FNSF Response to Transpower New Zealand Limited Submission

Far North Solar Farm Limited (FNSF) thanks Transpower New Zealand Limited for its submission in respect of The Point Solar Farm application under the Fast-track Approvals Act 2024.

Figure 1: Site Layout Plan showing BEN-ISL-A corridor and easement alignment.

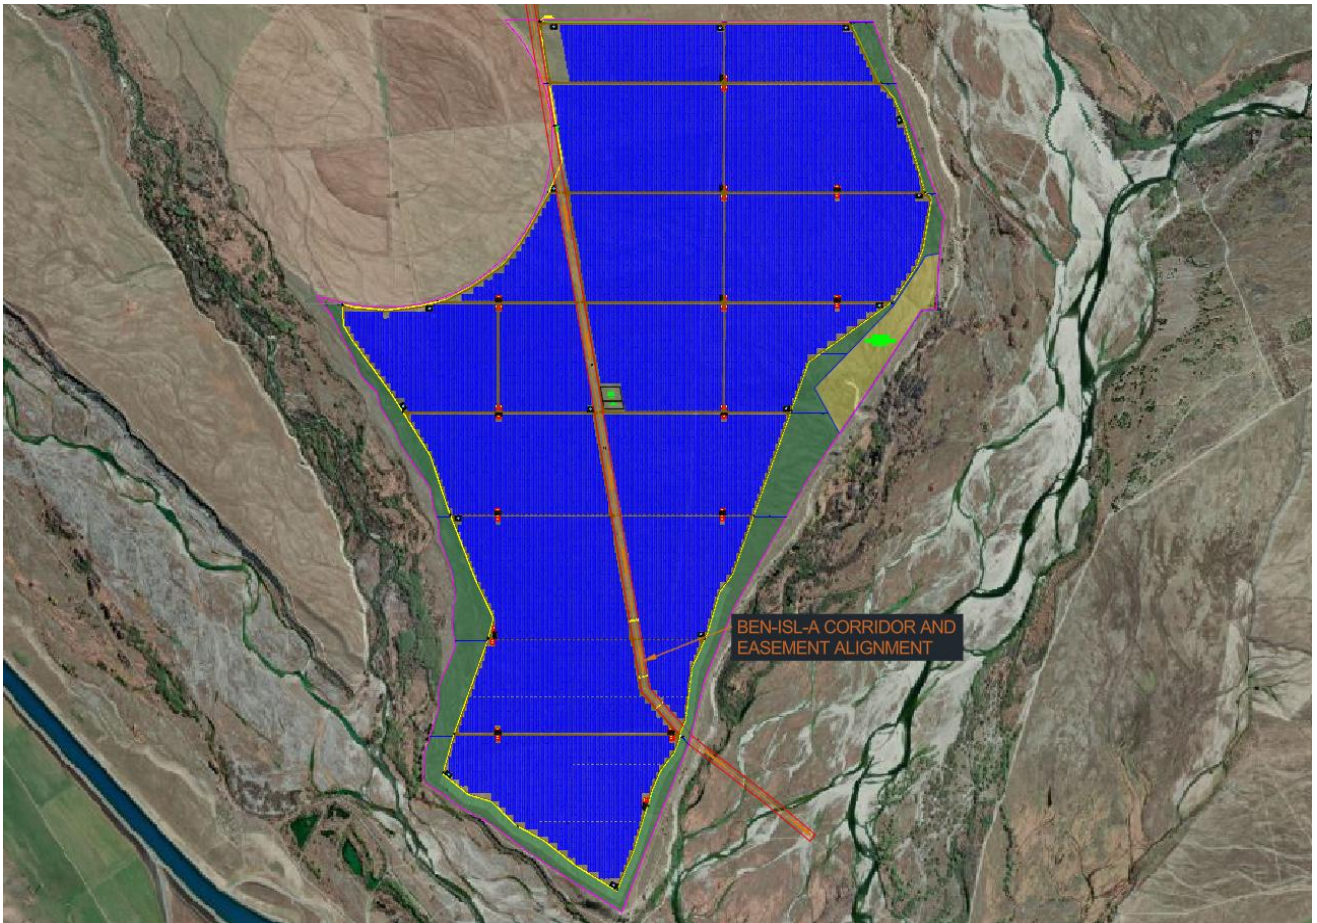
The BEN-ISL-A transmission line traverses the site north-south and is subject to a 12m National Grid Yard (NGY) either side of the centreline.

FNSF confirms:

- No buildings or permanent structures are proposed within the NGY.
- All works will comply with NZECP34:2001.
- The site layout maintains appropriate separation from towers BEN-ISL-A0079 to BEN-ISL-A0088.
- The easement line is set at 20m from the centre of the transmission tower and runs continuously along the full corridor.

Figure 2: Road cross-section and setback illustration.

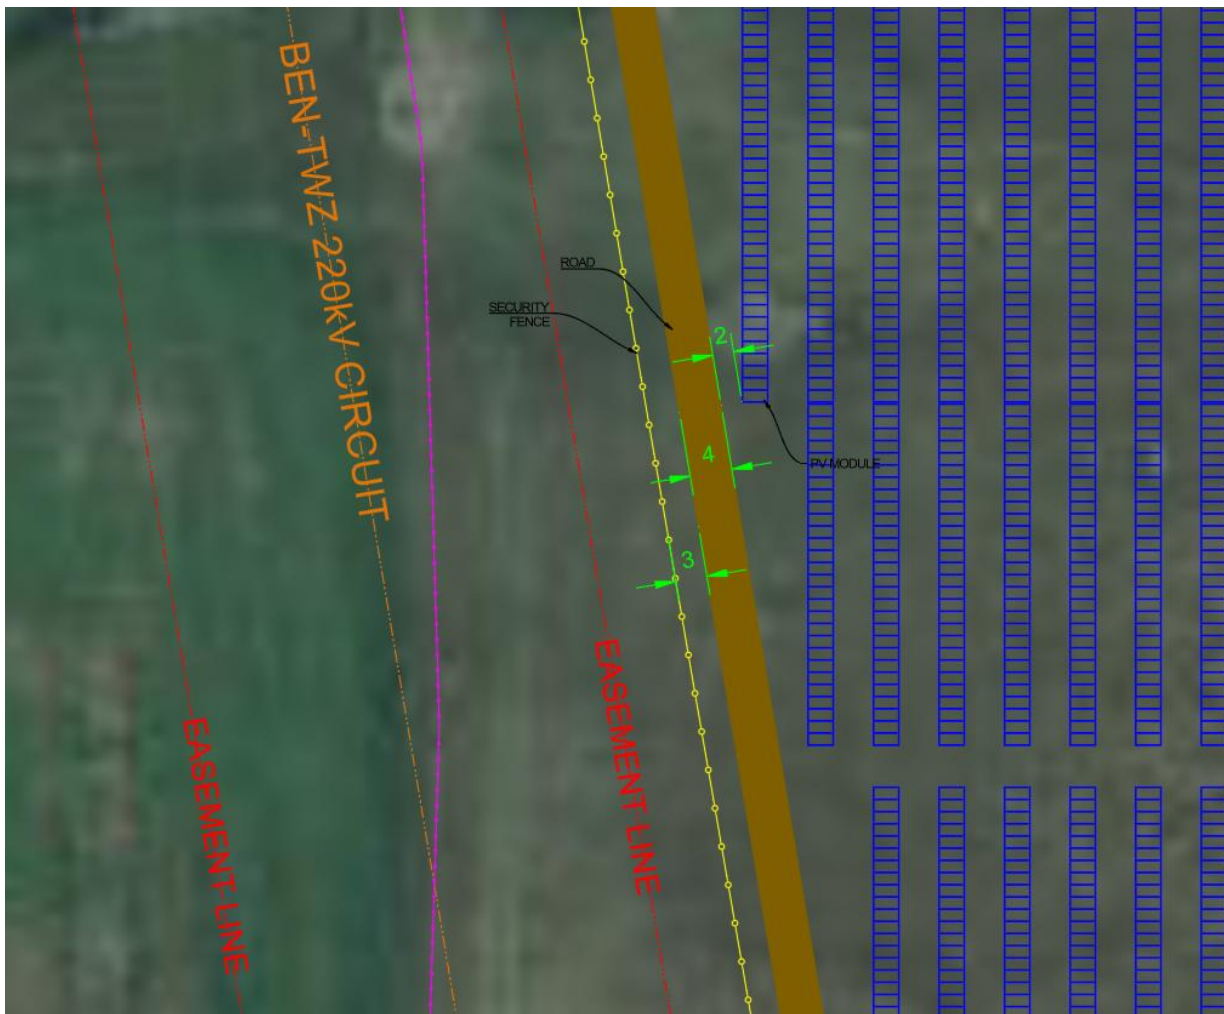
Transpower requested confirmation that internal accessways servicing National Grid assets provide a minimum 6m physical width.

- The formed road width is 4m.
- A minimum of 1m clearance is provided on either side.
- In practice, the layout provides approximately 9m total physical width (3m setback to security fence + 4m formed road + 2m setback to PV modules).

This exceeds Transpower's minimum requirement. The plant road extends from the main entrance to tower BEN-ISL-A0079 and provides continuous access along the corridor.

Figure 4: RMM Proposed Landscape Mitigation Plan addressing transmission tower at the boundary

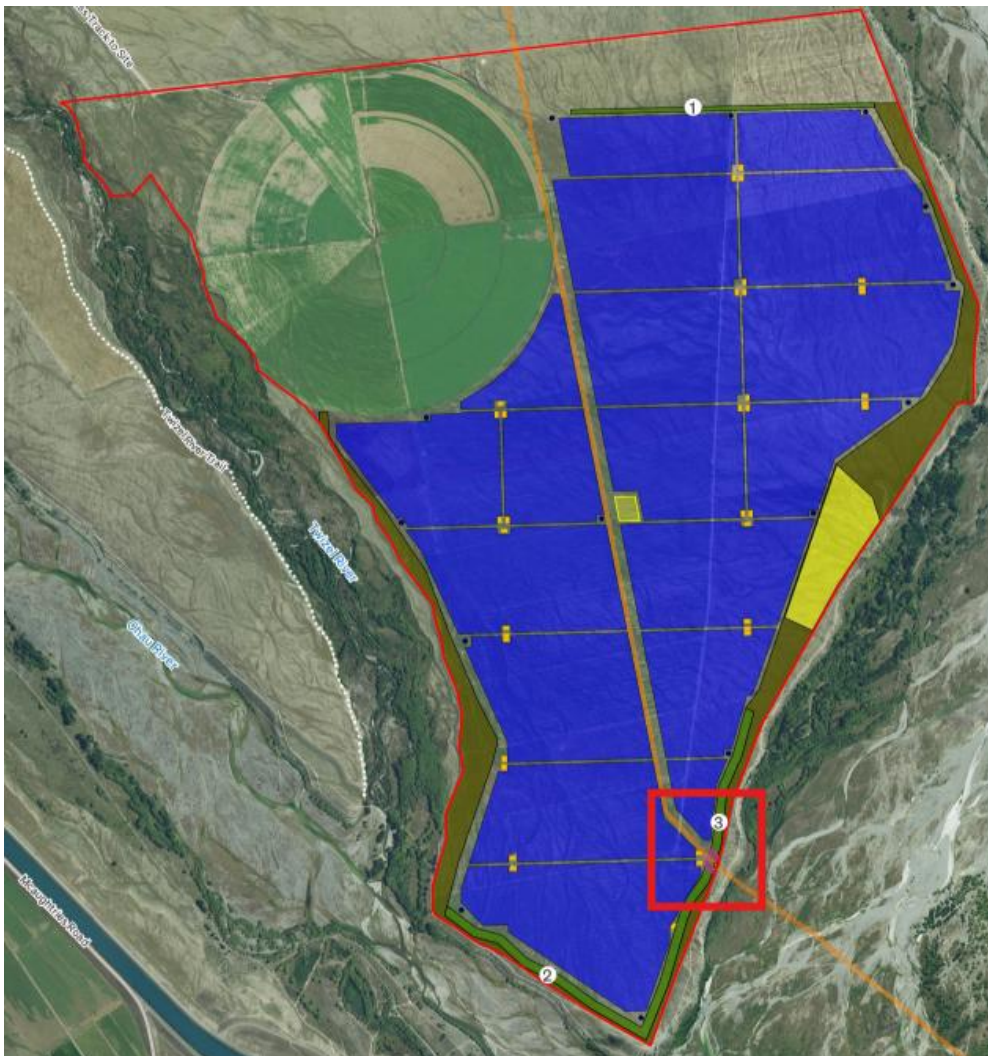
Transpower comments in relation to the planting proposed near the National Grid assets.

As per the RMM response, the Landscape Mitigation Plan has been updated to capture Transpower’s comments in their paragraphs 4.11 – 4.14. Notable:

The proposed plant species within 12m either side of the centreline of Transpower transmission line, being a 24m long x 35m wide area will consist of the following plant species, or similar, that have a mature height of no taller than 3m.

- *Carmichaelia kirkii* (Kirk's Broom)
- *Carmichaelia petriei* (Petrie's Broom)
- *Ozothamnus leptophyllus* (Cottonwood)

A Transpower Transmission Line Setback Area has been included. This area measures 30m north and 30m south from the outside of the transmission lines. The accompanying note stipulates that proposed plants within the Transpower Transmission Line Setback Area must be situated so when they are mature, they cannot fall and land within 4m of the transmission line.

And the transmission tower is partly within the Landscape Mitigation Area. A note has been included on the RMM Landscape Mitigation Plan stating that all plants will be setback 12m from the Transmission Tower attached with the statement above in section 2.8.
